RE: TEDS Exception No. 29-03 to Reduce Tangent Lengths & Radii along Woodridge Circle  
at 2561 G1/2 Road

### DESIGN EXCEPTION #DE29-03

**Woodridge Subdivision**

**WOODRIDGE  
SUBDIVISION**  
PRJCT NO.: 202103 FILE NAME: 202103-site.dwg

EXHIBIT 1

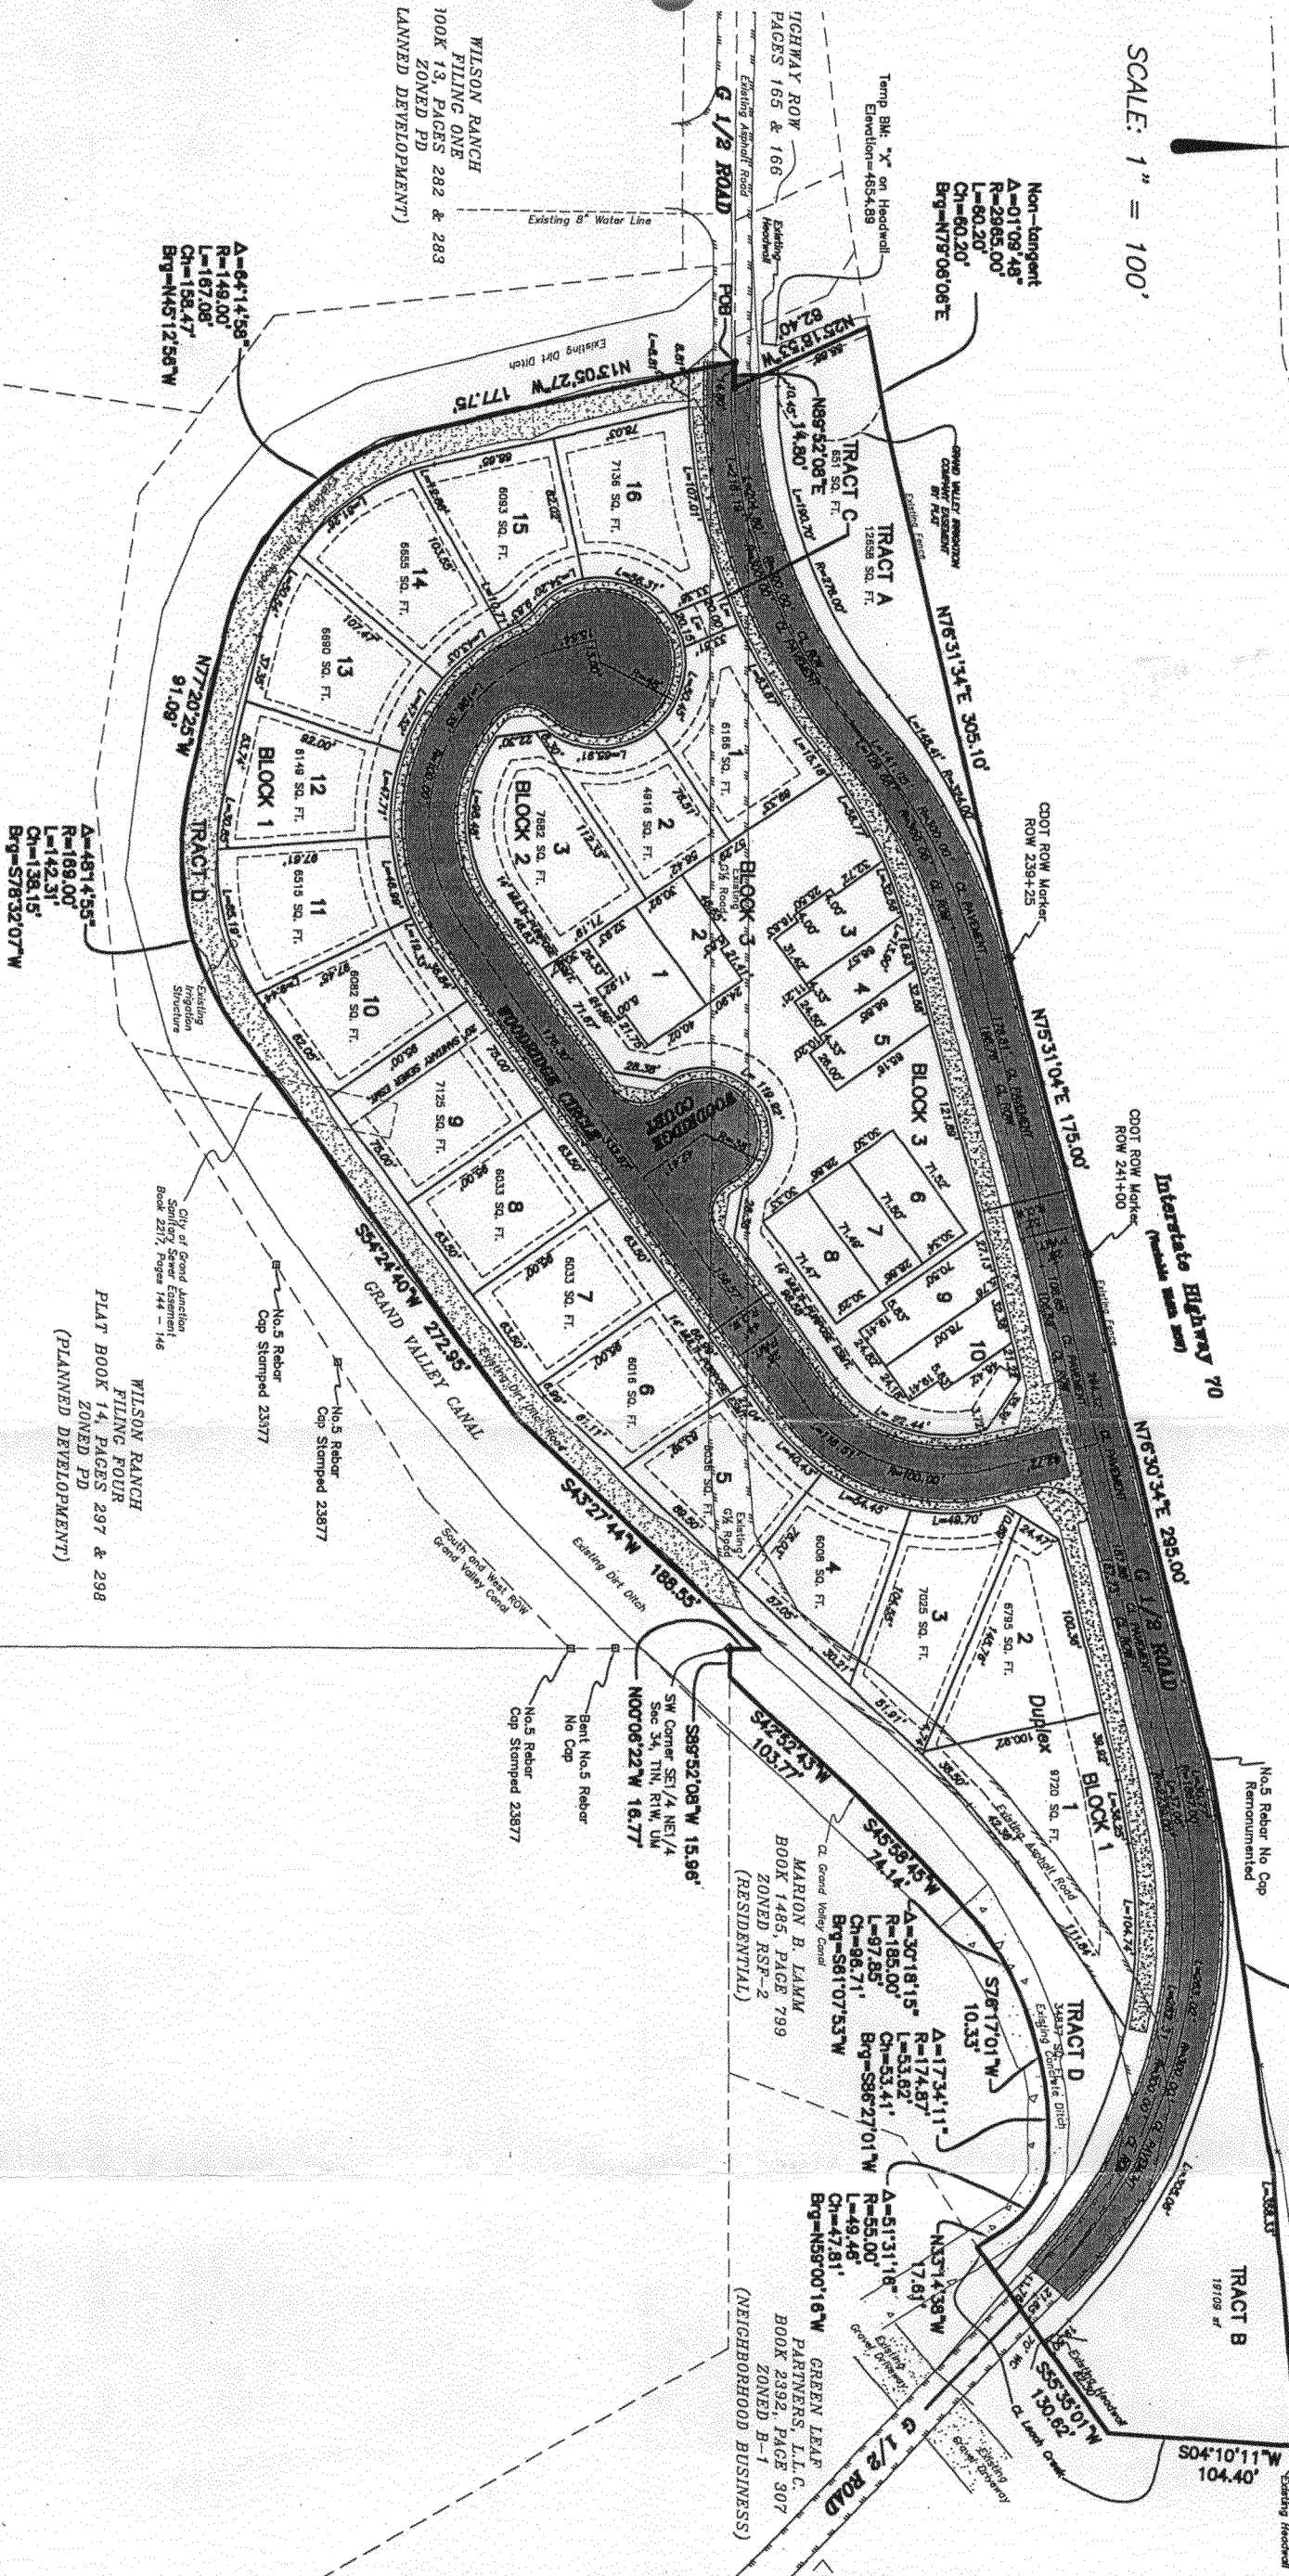
Applicant is planning to construct a new subdivision along G1/2 Road between Wilson Drive and 26 Road. The project would re-align G1/2 Road to run along the south edge of Interstate 70. Due to the unique shape of the parcel the proposed plan includes centerline radii along Woodridge Circle of only 100 feet instead of 150 feet and an approach tangent on Woodridge Court of only 47 feet instead of 75 feet.

The developer is requesting an exception to the 'Alignments – Curve Radii/Approach Tangent at Intersections' defined in Section 5.1.4.2 of the TEDS manual. The revised layout shown in Exhibit 1 utilizes an approach tangent of approximately 47 feet whereas the TEDS Manual requires a minimum length of 75 feet.

The developer is requesting an exception to the 'Alignments – Curve Radii' defined in Section 5.1.4.2 of the TEDS manual. The revised layout shown in Exhibit 1 utilizes centerline curve radii of 100 feet whereas the TEDS Manual requires a minimum radius of 150 feet.

I am in favor of a waiver of the tangent length, as this will be a low volume approach that will still allow approximately 140' of approach visibility to the required stop sign posting at G ½ Rd. Additionally, the approach alignment at G ½ Rd will allow adequate view of approaching G ½ Rd for both directions.

In a matter aside from this Exception application, however, the submittal does raise other questions of access, however. I have not previously seen this submittal, and am not clear as to how the lots 1, 2, and 3, at the east end of the site, will be accessed. There will be need to clarify access point placement for these lots, with respect to intersection clear zones, access spacing, and access route alternatives.

For clarification of the opening paragraph statement, the Woodridge Cir approach alignment will allow an eastbound vehicle a minimum of 3 seconds to observe and respond to the stop sign at G ½. This assumption is based on a "worst case" 30mph (44 / sec.) approach speed. Also, as mentioned in the first paragraph, the Woodridge alignment at the stop sign at G ½ Rd will provide optimum visibility of both directions of approaching G ½ Rd traffic.

- (Curve Radii – TEDS 5.1.4.2, proposing 100' centerline radii instead of 150' centerline radii) It seems that our default standard at this point is that a developer must demonstrate that fire access can be maintained around a corner assuming parked vehicles on each side of the street (33' min. interior radius, 48' min. exterior radius). A 100' centerline radius easily accomplishes this. I recommend approval of this request.

- (Approach Tangents – TEDS 5.1.4.2, proposing 47' tangent instead of 75' tangent) TEDS requires the 75' tangent distance to "provide for adequate sight distance for traffic control devices at the intersection." This distance seems excessive for a dead-end residential street (or any residential street for that matter). Other than that observation, I see no reason to support (or deny) this request. Generally, I don't see any problem with the request. However, if we approve this exception, we should seriously considering a permanent revision to TEDS.

I recommend approval of the requested Design Exceptions to Section 5.1.4.2 to allow the proposed Street layout.

I have reviewed DE29-03 and concur with Mike's recommendation for approval.
